Agenda
WATERTOWN BOARD OF ADJUSTMENT
City Council Chambers
23 2nd Street NE

1. Approval of 11/10/16 Minutes
2. Applicants Michael & Angela Bevers (#17137) appeal the terms of the Zoning Ordinance, seeking variance relief from the requirements of Chapters 21.03, 21.60 & Section 21.1002, to allow for the construction of a nonconforming unattached garage in the R-1 Single Family Residential District @ 1101 Skyline Dr.

- A. Public hearing
 - B. Board of Adjustment action
3. Applicant Edward Spies for Spies Corporation (#17138) appeals the terms of the Zoning Ordinance, seeking variance relief from the requirements of Chapters 21.03, 21.60, 21.73 & Section 21.1003, to allow for the construction of a nonconforming commercial building in the C-3 Highway Commercial District @ 920 3rd St SE; concurrently, applicant seeks Conditional Use approval to allow for Storage Units in that structure per §21.2803(12), and contingent upon compliance with Specific Rules Governing Individual Conditional Uses including but not limited to §21.0202(2)b(6a-h).

Appeal #17137

PLOT PLAN

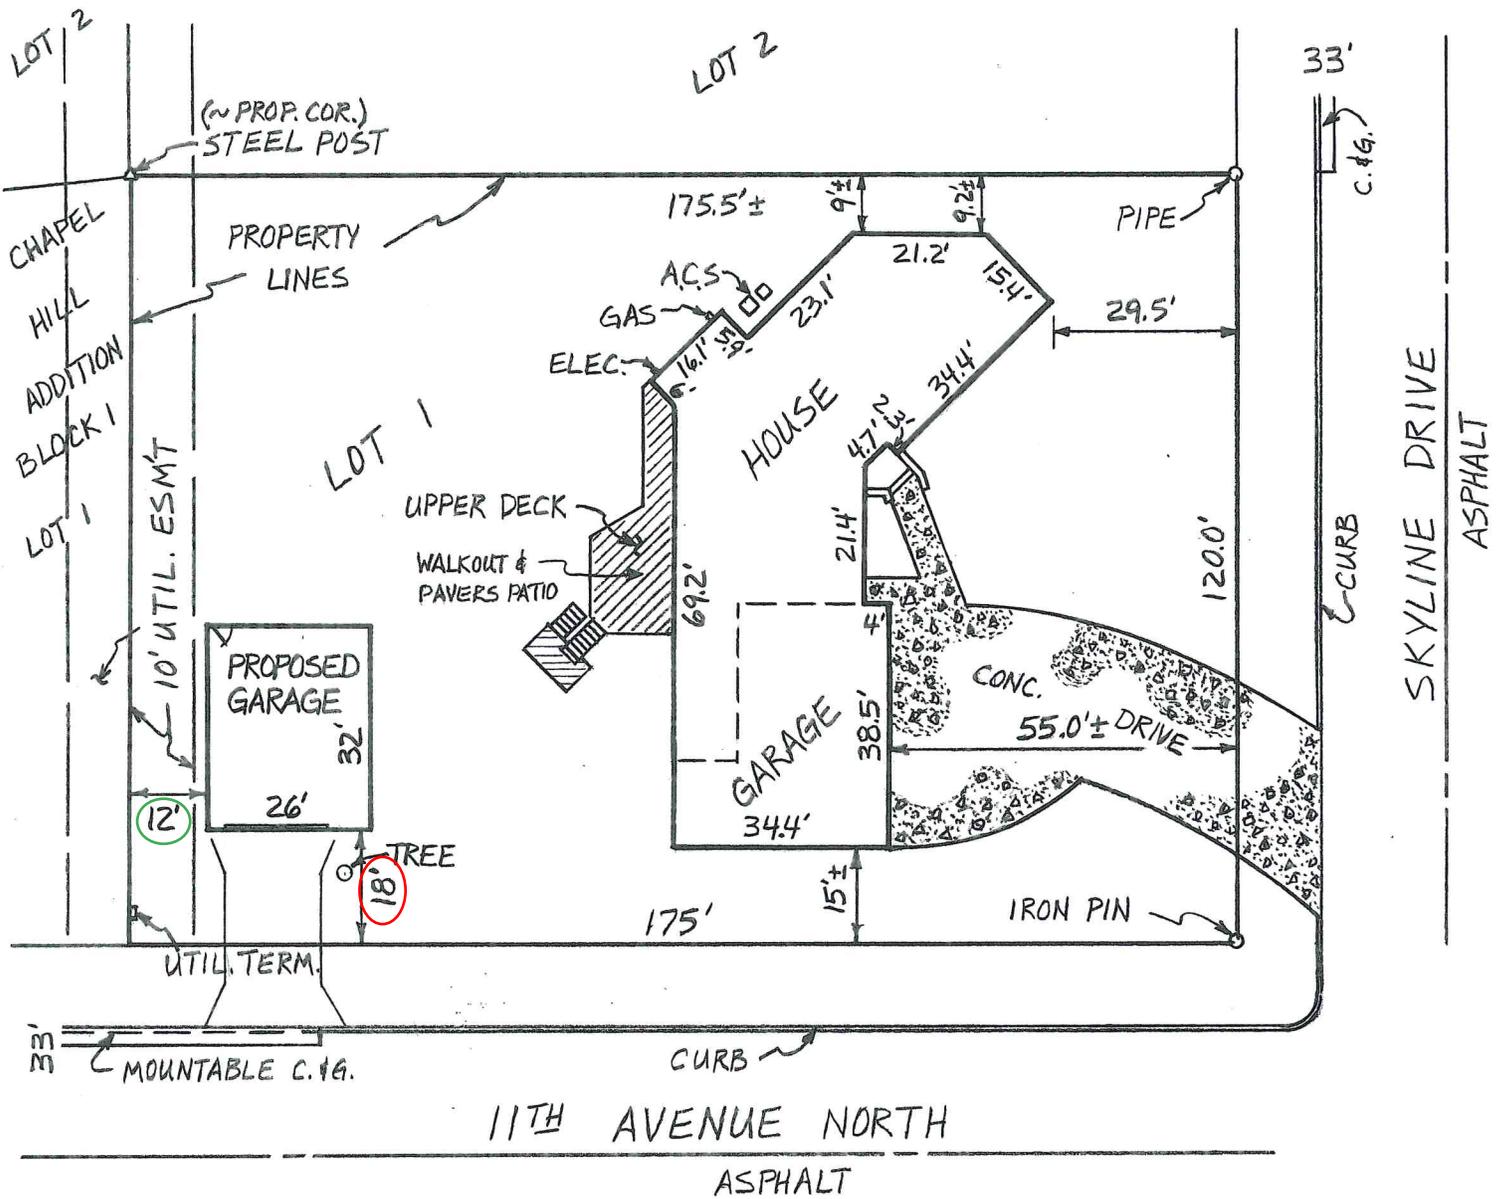
1. **Application was submitted** requesting to construct a **nonconforming 832 sq ft (26'x32')** **unattached garage** on a 21,030 sq ft parcel located in the R-1 Single Family Residential District; said structure proposed to be constructed:

- **18'** from the front (south) property line, where a minimum **25'** setback is required.
2. **Application was denied** based on the following ordinance regulations:

- There is sufficient buildable area on this 21,030 sq ft lot to construct a compliant garage of equal or greater area, without variance.
- In addition to noncompliant setback, eighteen ft (**18'**) is also not sufficient off-street parking length in front of the proposed garage, as any vehicle parked there will encroach into the public Right-of-Way and over the pedestrian walkway (required to be improved with a 4' wide concrete sidewalk). Note: twenty ft (**20'**) is the minimum parking space length required in front of garage doors opening onto an alley ROW or onto Lake Drive ROW per Ordinance §21.1002(3). According to Engineering Design Standards, eighteen and one-half ft (**18.5'**) is the minimum parking space length for a 90° parking space off of a driving aisle/ROW.

Site Plan of Block 2 of the plat of Poulson's Addition to Watertown and that portion of Vacated 10th Avenue South adjacent to Block 2.

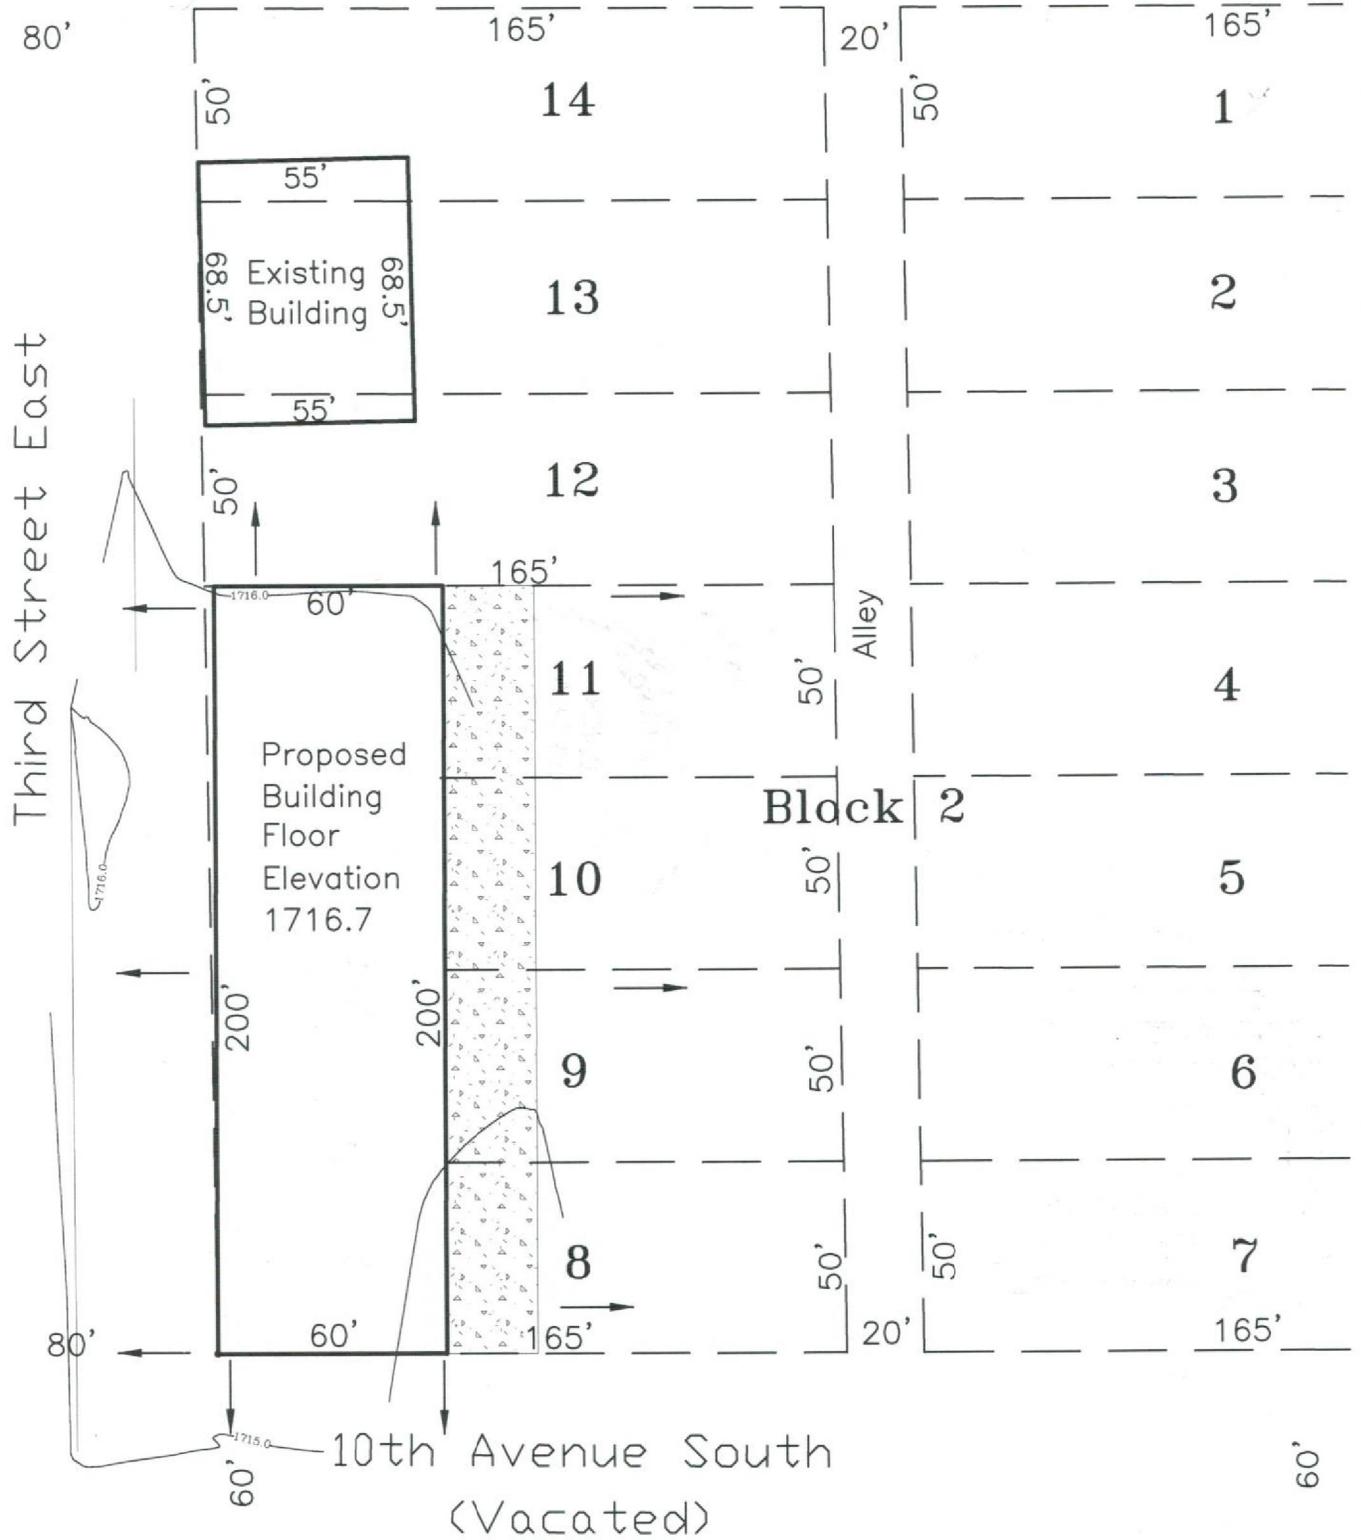
- Site Plan does not show grassed Blvd w/trees (1 tree/50' of frontage) 11 total for lots 8-14 & vac street.
- Lighting and screened dumpsters were not addressed.

- **0'** from the front (west) property line, where a minimum **40'** setback is required; and
 - **without boulevard improvements**, where a minimum width **fifteen ft (15')** **grassed boulevard with one (1) tree per fifty ft (50')** of frontage is required.

- In addition to noncompliant setback, zero ft (0') is also not sufficient length in front of the eleven (11) proposed west-facing overhead garage doors, as any vehicle loading/parked there will encroach into the public Right-of-Way and obstruct the pedestrian walkway (required to be improved with a 4' wide concrete sidewalk). Furthermore, the applicant's utilization of two hundred ft (200') of the boulevard for their own (customers') loading/unloading/parking purposes, as reflected on the Site & Floor Plans, leaves no area for the fifteen ft (15') grassed boulevard and four (4) trees required to be installed & maintained there. Note: twenty ft (20') is the minimum parking space length required in front of garage doors opening onto an alley ROW or onto Lake Drive ROW per Ordinance §21.1002(3). According to Engineering Design Standards, eighteen and one-half ft (18.5') is the minimum parking space length for a 90° parking space off of a driving aisle/ROW.
